PROJECT: Summitlin West V22-Flight Edge Way
(From Kettle Bend to Desert Foothills)

CITY OF LAS VEGAS		DATE:
INTER-OFFICE MEMORANDUM		April 21, 2020
TO: Land Development Services Department of Building & Safety		FROM: Albert Sung, P.E. Flood Control Project Engineer Department of Public Works
SUBJECT:	Drainage Study for:	COPIES TO:
	Summerlin West V22 – Flight Edge Way (from Kettle Bend to Desert Foothills)	VTN Nevada
Cross Streets:	Desert Foothills Blvd. & Flight Edge Way	Howard Hughes Company, LLC
File Number:	F:\Depot\DSMemos\DS5252B.doc	Bart Anderson, P.E., DevCo
Parcel Number:	137-23-201-001	CCRFC
Zoning Action:	N/A	
FEMA Flood Zone	YES	NO X
Proposed Storm Drain	YES	NO X

ADDENDUM #1
TO THE TECHNICAL DRAINAGE STUDY
FOR
V22 FLIGHT EDGE WAY –
KETTLE BEND TO DESERT FOOTHILLS
DS-5252
CITY OF LAS VEGAS, NEVADA
W.O. # 7861

This Addendum #1 to the Technical Drainage Study for V22 Flight Edge Way – Kettle Bend to Desert Foothills (DS-5252) is being submitted to the City of Las Vegas Department of Public Works to address review comments dated March 17, 2020.

LAS VEGAS VALLEY WATER DISTRICT APPROVAL
APPROVED FOR CONSTRUCTION
LAS VEGAS VALLEY WATER DISTRICT ENGINEERING SERVICES
DATE: _____ PROJECT: _____
LVVWD APPROVED FIRE FLOW 1,500 GPM AT 20 P.S.I. RESIDUAL

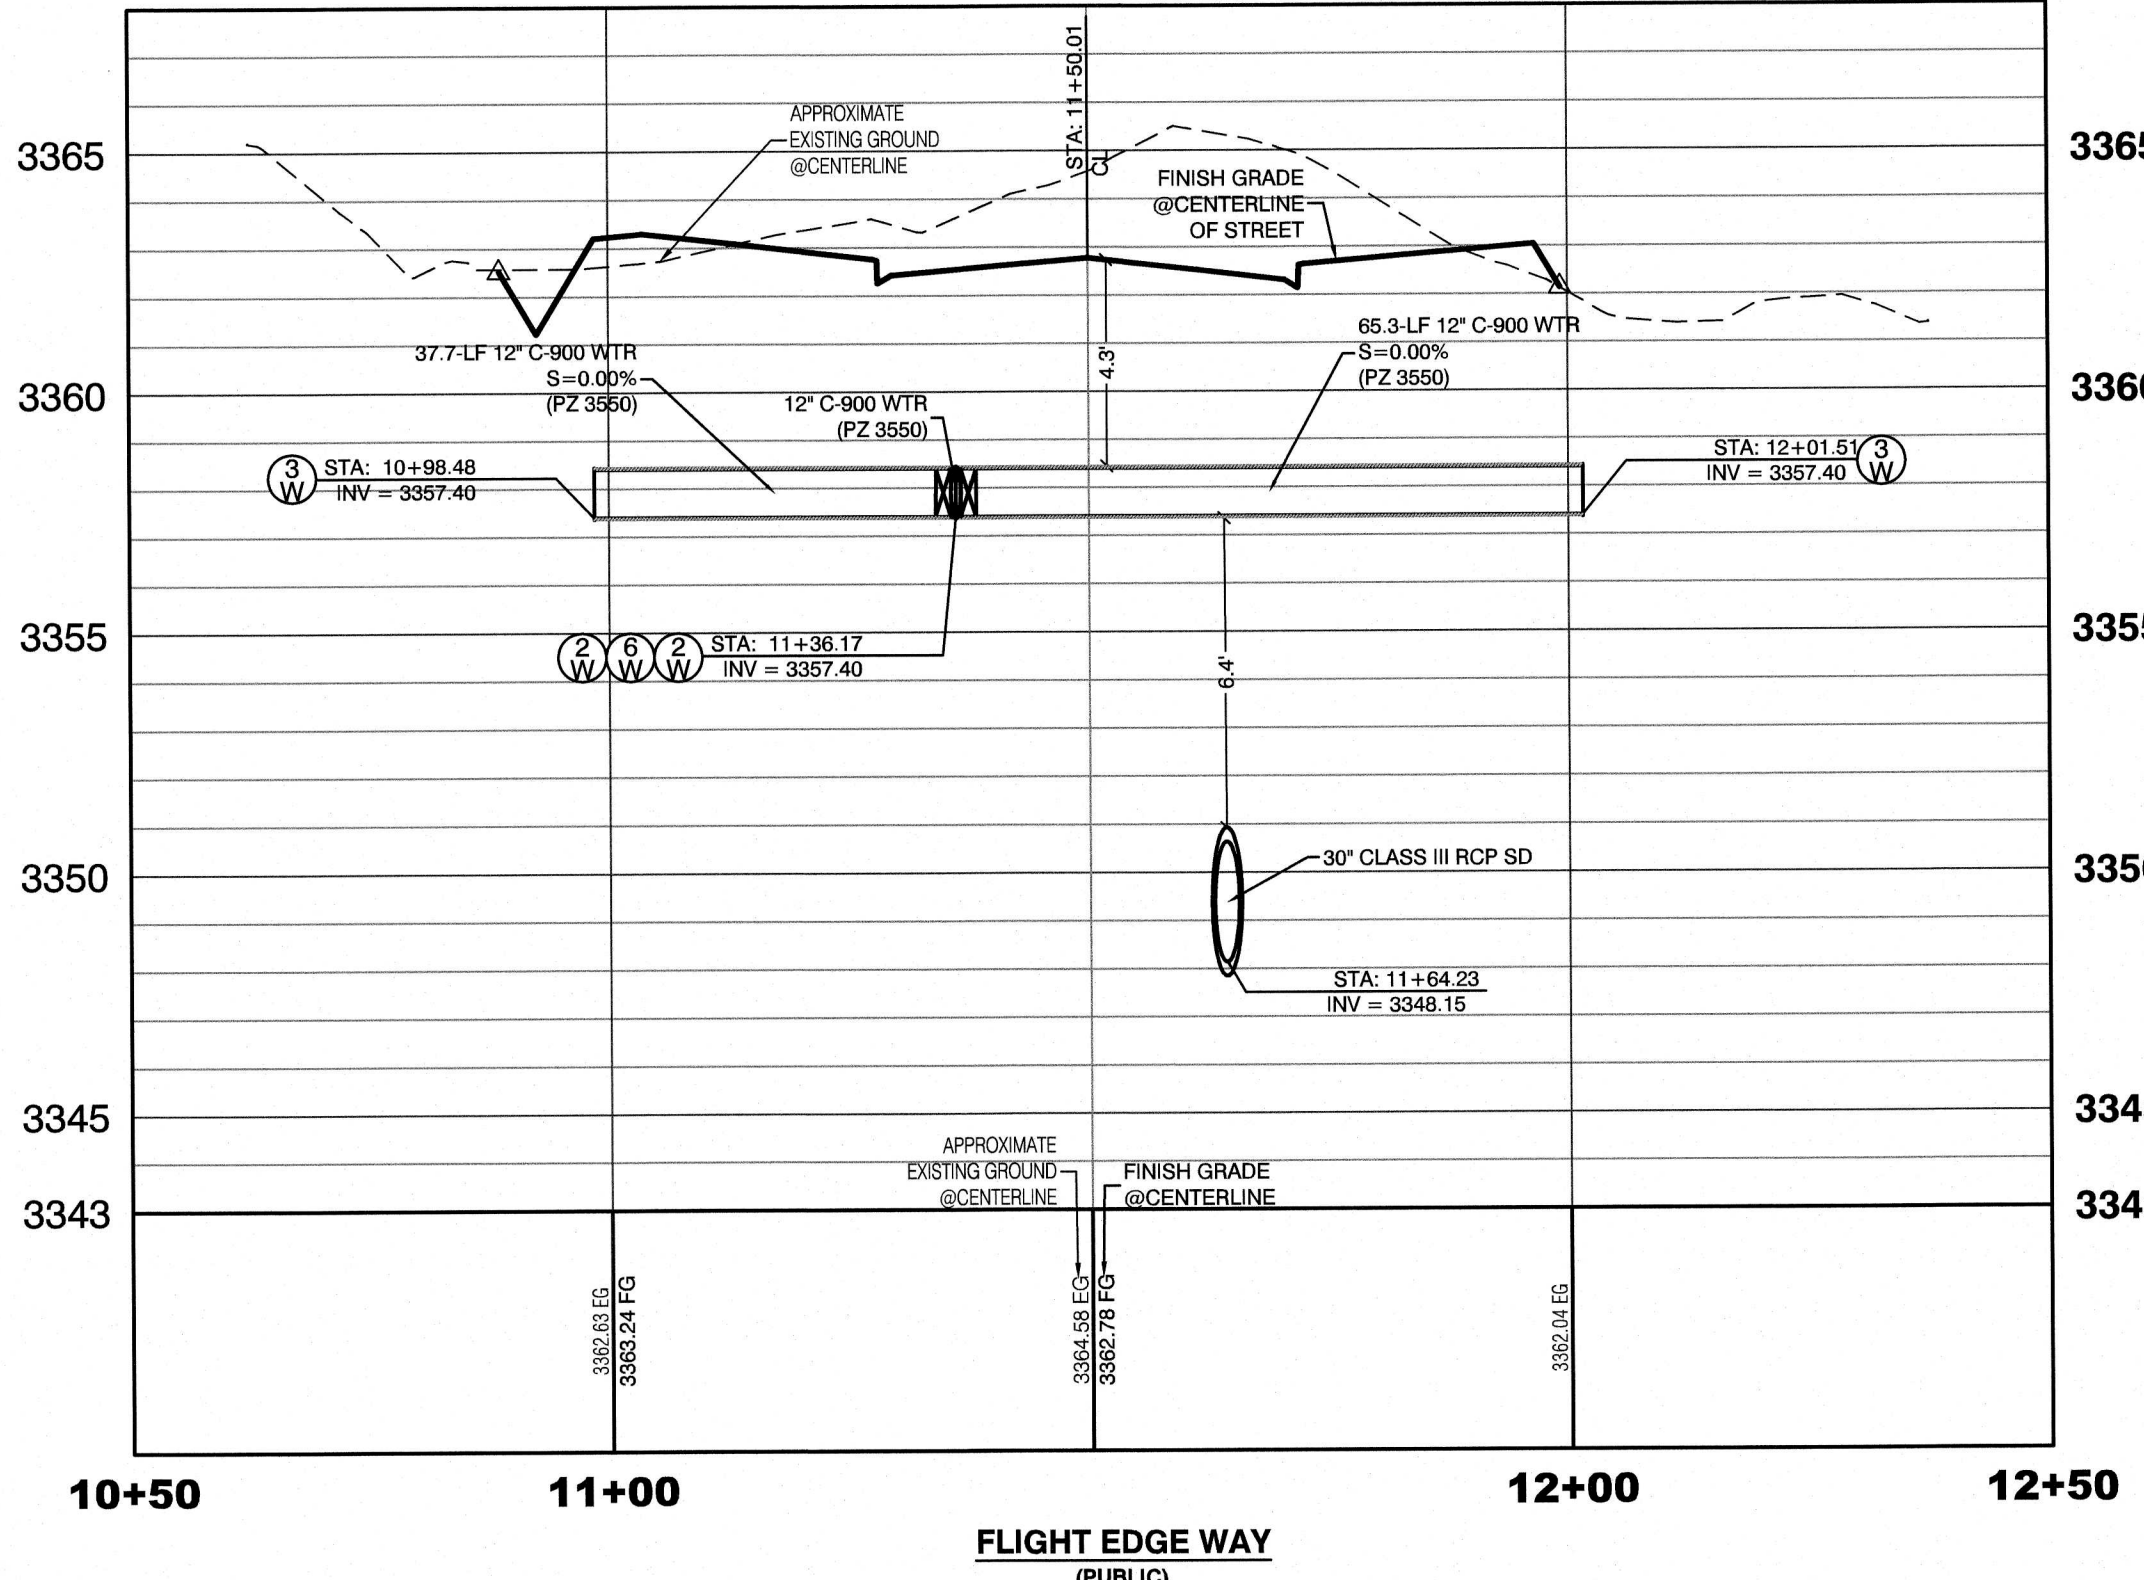
Sheet UT3 and Sheet UT7: At the connection point between the existing 30" RCP and the new one in Flight Edge Way, provide a connection detail such as collar in the next submittal.

RESPONSE: The existing RCP will be cut back to provide a clean joint as required to connect the new RCP. Note that the RCPs will have the same slope and no deflection between the existing and proposed pipes will occur. Non concrete collar is necessary.
